SERVICE INFORMATION

NO. SI 50-002

Garmin Service Bulletin No. 22117 Rev. B

SERVICE BULLETIN

Figure 1 - 233-00075-01 and 233-00075-02 Cable Retention Pins

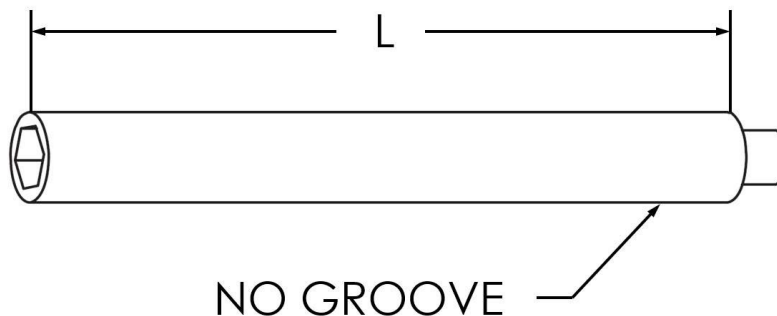
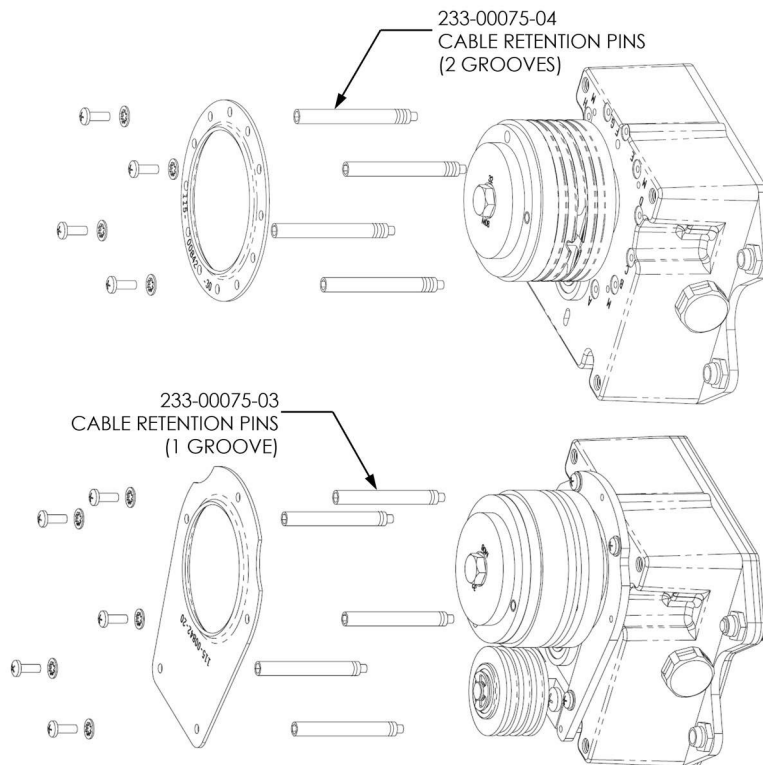
Garmin has issued Service Bulletin No. 22117 Rev. B recommending replacement of the cable retention pins with new longer cable retention pins at the GSM 86 servo gearbox assembly.

Both the -01 and -02 Cable Retention Pins have no grooves (See Figure 1). The -01 Cable Retention Pin is 1.48" long and the -02 is 1.60" long (See Figure 1).

In the event of the loss of the clutch retaining bolt, the output shaft drive pin may become partially disengaged causing the capstan to bind.

This Service Bulletin contains instructions to replace the cable retention pins with new longer cable retention pins to ensure the GSM servo gearbox capstan is free to rotate in the event that the clutch retaining bolt is not retained.

1. Refer to the applicable airframe specific maintenance manual to gain access to the GSM 86.
2. Gain access to the cable guard pins by removing cable guard hardware including screws, washers, and top ring.
3. Replace each cable retention pin with a new part number as listed in Table 1.

New Pin P/N	Replaces Pin P/N
233-00075-03 (one groove)	233-00075-01 (1.48")
233-00075-04 (two grooves)	233-00075-02 (1.60")

4. Make sure the same hole locations are used as the existing cable guard pins and torque to 6-8 in-lbs.
5. Install the removed cable guard hardware and torque screws to 6-8 in-lbs.
